# Access Compliance Report

## Public Rights-of-Way

Intersection ID: 2927	Main Street: DOWNFIELD_WOOD_DR	Cross Street: RIDGEFIELD_DR	Location: NW
ADA ID: F37C6F6B4CF5	Ramp Type: Perp	Initial Pass/Fail: Fail	Overall Compliance: No
Severity Score: 10			
Codes/Mitigation Info/Possible Solution		Field Measurements/Component Compliance

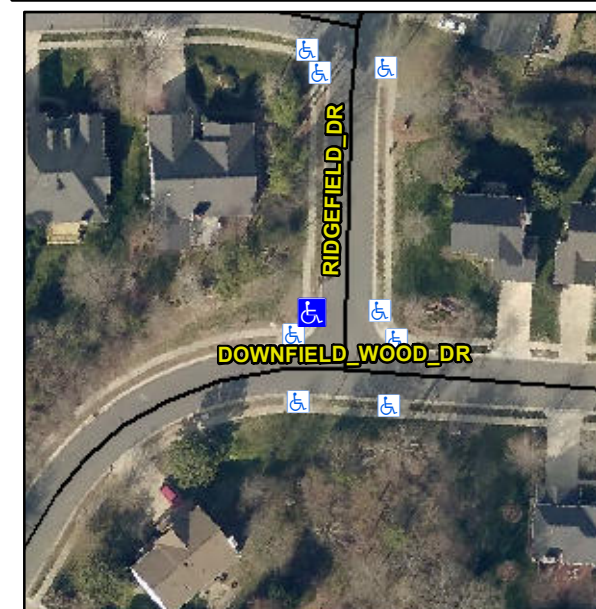
**Remove & Replace Entire Ramp.**

**R304.5.1, R304.5.3**

Compliance	Description	Data	Compliance	Description	Data
N/A	Ramp Length (in)	46.0	Yes	Ramp Slope (%)	5.1
No	Ramp Width (in)	37.0	No	Ramp XSlope (%)	2.5
N/A	Flare Type LT	N/A	N/A	Flare Type RT	N/A
N/A	Flare Slope LT (%)	N/A	N/A	Flare Slope RT (%)	N/A
N/A	Flare Traversable LT?	N/A	N/A	Flare Traversable RT?	N/A
N/A	Landing Length (in)	N/A	N/A	DWS Provided?	N/A
N/A	Landing Width (in)	N/A	N/A	DWS Contrast?	N/A
N/A	Landing Slope (%)	N/A	N/A	DWS Length (in)	N/A
N/A	Landing X Slope (%)	N/A	N/A	DWS Full Width?	N/A
N/A	Landing Curb? (Y/N)	N/A	N/A	DWS Offset (in)	N/A
N/A	Shared Landing?	N/A			
N/A	Gutter Ponding?	N/A	N/A	Gutter Slope (%)	N/A
N/A	Gutter Lip Ht (in)	N/A	N/A	Gutter X Slope (%)	N/A
N/A	Painted X Walk1?	No	N/A	Painted X Walk2?	N/A
	X Walk 1 Direction	To E		X Walk 2 Direction	N/A
N/A	X Walk 1 Width (in)	N/A	N/A	X Walk 2 Width (in)	N/A
	X Walk 1 Slope (%)	1.5		X Walk 2 Slope (%)	N/A
	X Walk 1 X Slope (%)	2.8		X Walk 2 X Slope (%)	N/A
